Architectural Review Board Staff Report

Project Type: Amended Site Development Plan

Description: **Tower Center, Lot AA (Pets & Company)**: An Amended Site Development Plan, Amended Architectural Elevations and Statement of Design for a 2.01 acre tract of land zoned "PC" Planned Commercial District located on the northwest corner of Long Road and Edison Avenue.

Figure 2: Color Site Plan

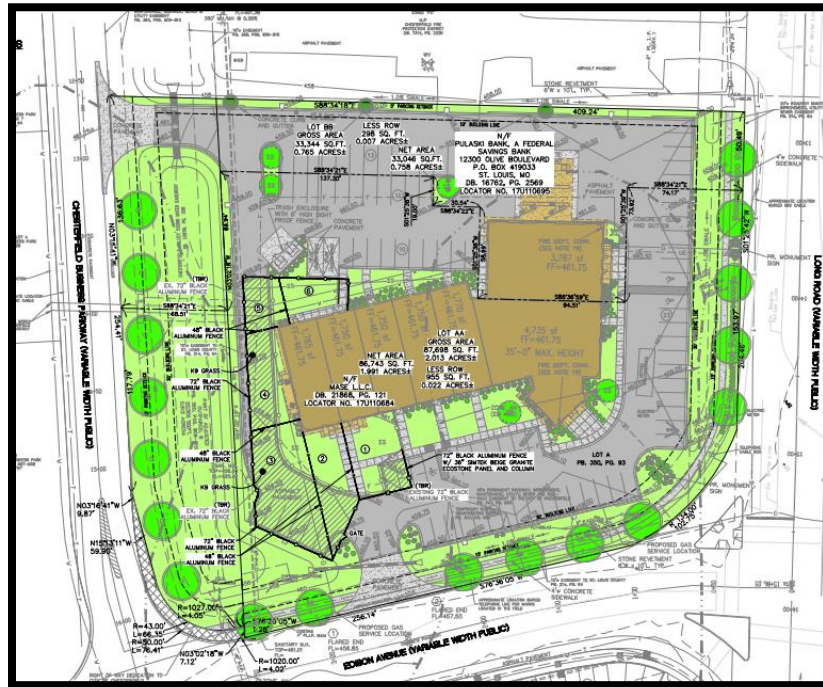
No changes are proposed to the building itself. The applicant is proposing an extension of the fencing materials. Please see photos above for the proposed changes.

Fencing along the western edge will be similar to the black metal, six-foot tall existing fencing currently on the site. Additionally, there is an existing beige panel wall near the door that is approximately three feet (3') tall, with an additional three feet (3') of black metal fencing on top. The applicant is proposing to increase the amount of this fencing to bring it further away from the building into the parking lot. Finally, the ground in all of the play areas will be covered with K9 grass, a faux turf on top of aggregate to assist with drainage and odor.

A small portion of mulch of the site's existing landscaping will be removed and replaced by K9 grass during this expansion. The specific area is located on the northeast side of the entrance near the light post.

Exhibit B

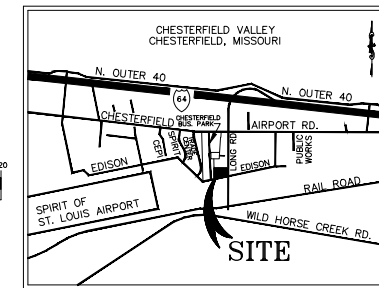
We would like to use the ½ faux stone½ aluminum Simtek fencing that is currently along our sidewalk in the areas outlined in exhibit B. This fencing creates a visual barrier that aids in greatly reducing the alert barking our many guests vocalize each time they see a car, person, other dog or the USPS & UPS delivery drivers. Eliminating the excessive barking is our number one concern. The noise from the barking is very unwelcoming to our clients, it is very disturbing to our neighbors and their customers and it also causes a major disruption in our pack of dogs leading to fights and aggression. Eliminating the barking will benefit our 4 legged and 2 legged guests, increase the safety of our staff and dogs and most importantly it will make Pets & Company a welcoming business that isn't an annoyance to our neighbors and visitors. Increasing the outdoor space will allow our guests more room to exercise and the new turf and drainage tiles will eliminate the odor issues we have with our current drainage system.

I have reviewed your request, and have consulted with Operations, and have determined it would be acceptable to us to remove the drive as shown on your request. The only concern I have is the re-location of the dumpster and loading zone. The dumpster and loading zone should be located such that the dumpster is at least 15 feet from the building, and the dumpster and loading zone shall not interfere with fire department access.
